<b>AMENDMENT OF SOLICITATION/MODIFICATION OF CONTRACT</b>			1. Contract Number	Page of Pages 1   2	
2. Amendment/Modification Number <b>DCAM-2010-B-0122-003</b>		3. Effective Date 24-May-10	4. Requisition/Purchase Request No.	5. Solicitation Caption <b>See Below</b>

14. Description of amendment/modification (Organized by UCF Section headings, including solicitation/contract subject matter where feasible.)					
<p><b>Caption: Refurbish Hydraulic Elevator at Dept. of Motor Vehicles (DMV)</b></p> <p>The solicitation is being amended as follows:</p> <ol style="list-style-type: none"> <li>Delete #1 of Amendment DCAM-2010-B-0122-002 in its entirety. Section M in Solicitation No. DCAM-2010-B-0122 dated May 6, 2010 remains in full force and effect.</li> <li>Questions and Answers (Attachment A)</li> <li>Pre-bid conference Attendace Sheet (Attachment B)</li> </ol> <p>The opening date for receipt of bids, time and place remains the same.</p>					
Except as provided herein, all terms and conditions of the document referenced in Item (9A or 10A) remain unchanged and in full force and effect					
15A. Name and Title of Signer (Type or print)			16A. Name of Contracting Officer <b>Diane Wooden</b

# Standard Elevator Oil-Minder System Diagram

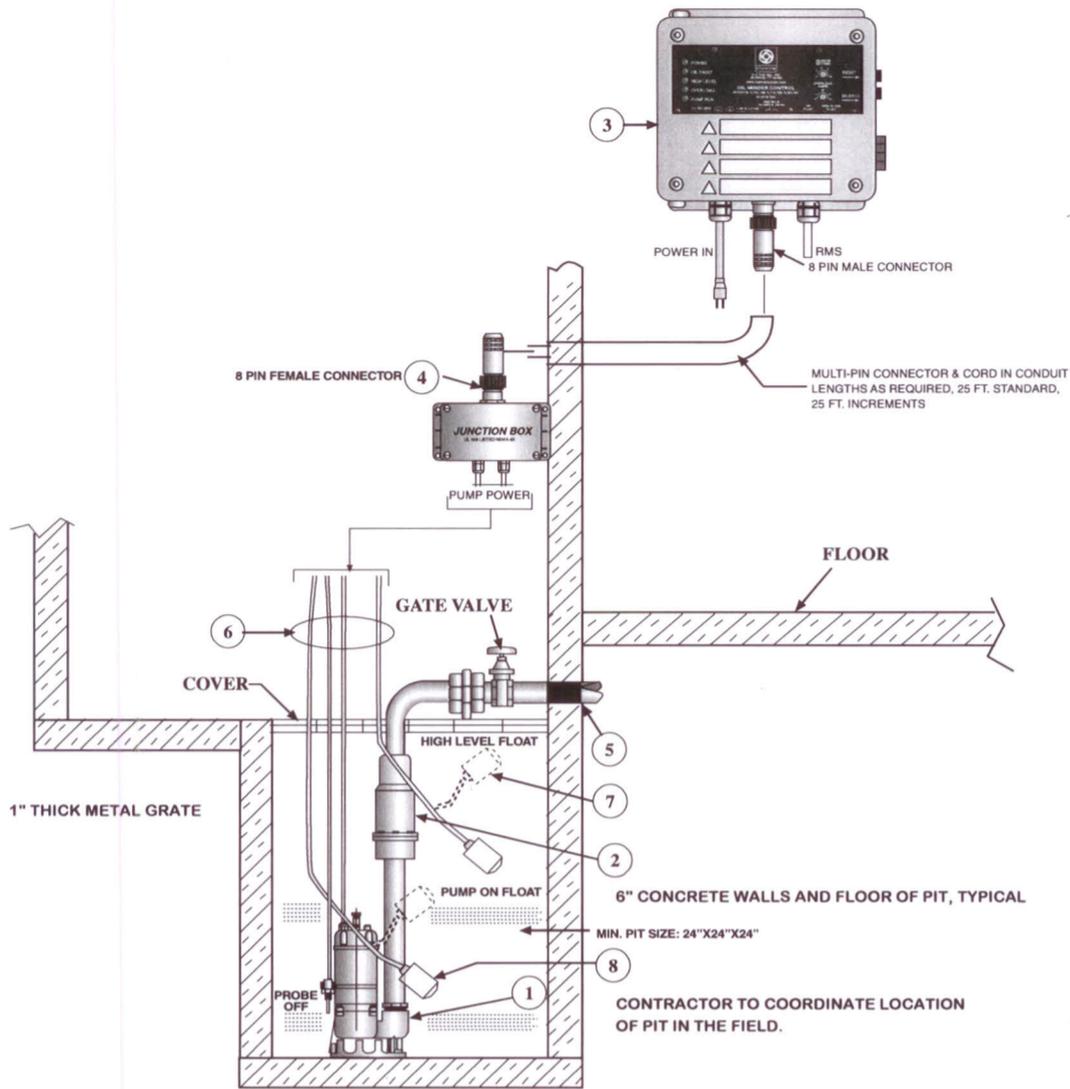
- 4. Question:** "Spec section 01900 Pt 1- General- related work 6.0 Waterproofing Pit- Provide details and specifications for required waterproofing. Is there a pit that the sump is to be set into? If so, provide details dimensions and details associated with the pit."

**Answer:** The waterproofing of the pit will include the provision of a new sump pit and pump indicated on the drawings and in the attached sketch. The recommended min. size of the pit opening is 24"x24"x24". The pit wall thickness and reinforcement shall match existing pit slab. The pit location needs to be coordinated with the elevator equipment. A typical detail of the pit and pump of the specified pump is attached for your reference.
